NL-09-076

Subject: **Indian Point Nuclear Power Plant Units 2 and 3
Application for Unit 2 Operating License Condition Change and Units 2 and
3 Technical Specification Changes to Add Inter-Unit Spent Fuel Transfer
Requirements**
Indian Point Units 2 & 3
Docket Nos. 50-247 and 50-286
License Nos. DPR-26 and DPR-64

**ANALYSIS OF PROPOSED OPERATING LICENSE CONDITION AND TECHNICAL
SPECIFICATION CHANGES PERTAINING TO
THE INTER-UNIT TRANSFER OF SPENT FUEL
FROM INDIAN POINT UNIT 3 TO INDIAN POINT UNIT 2**

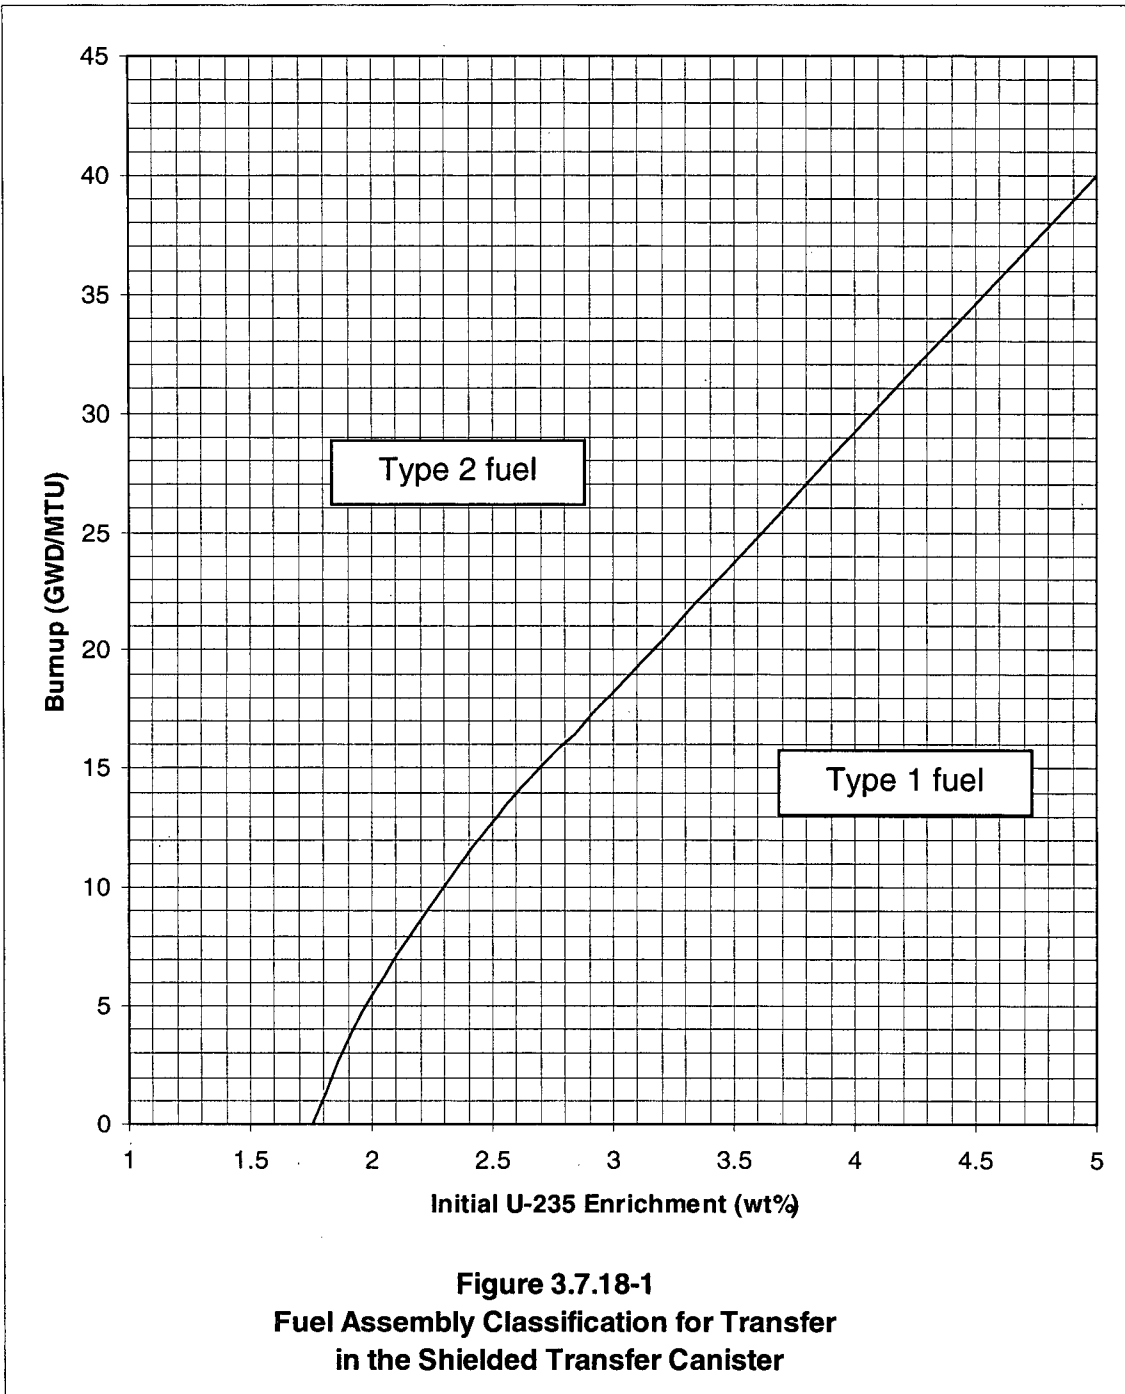
LCO 3.7.18 INTACT FUEL ASSEMBLIES placed into the Shielded Transfer Canister (STC) shall be classified in accordance with Figure 3.7.18-1 based on initial enrichment and burnup and shall be restricted based on the following:

- a. INTACT FUEL ASSEMBLIES classified as Type 2 and meeting the following may be placed in the STC basket (see Figure 3.7.18-2) as follows:
1. Post-irradiation cooling time ≥ 5 years;
 2. Average burnup per fuel assembly $\leq 55,000$ MWD/MTU;
 3. Decay heat ≤ 650 Watts (any cell);
 4. Decay heat ≤ 1105 Watts (cell 1, 2, 3 or 4).

- b. INTACT FUEL ASSEMBLIES classified as Type 1 or Type 2 and meeting the following may be placed in cells 5, 6, 7, 8, 9, 10, 11, 12 of the STC basket (see Figure 3.7.18-2) as follows:
1. Post-irradiation cooling time ≥ 5 years;
 2. Average burnup per assembly $\leq 55,000$ MWD/MTU;
 3. Decay heat ≤ 650 Watts.

Figure 3.7.18-2
Shielded Transfer Canister Layout
(Top View)

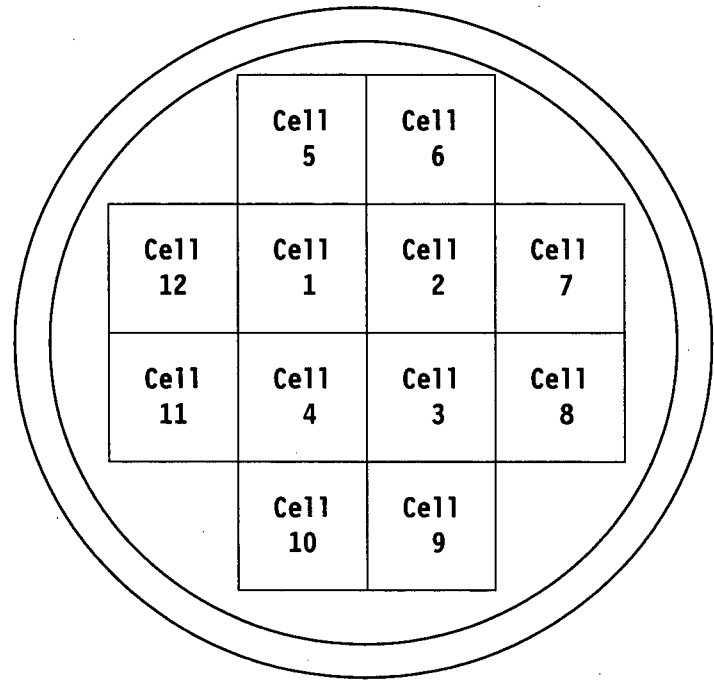
In the Shielded Transfer Canister (STC) design, the fuel basket is divided rectilinearly into twelve cells as shown in Figure 3.7.18-2, "Shielded Transfer Canister Layout (Top View)". All cells are sized to contain IP3 spent fuel assemblies. All cells are designed and analyzed for fuel of a certain enrichment, burnup, cooling time, and decay heat. The inner cells are designed and analyzed to contain fuel with slightly higher burnup and shorter cooling time. The fuel in the outer cells provides shielding for the fuel in the inner cells.

LCO 3.7.18.b is modified by a note stating that if one or more Type 1 assemblies are in the STC, cells 1, 2, 3, and 4 must be empty. The restriction preserves the assumptions of the bounding criticality analysis for Type 1 fuel assemblies placed only in the peripheral fuel cells.
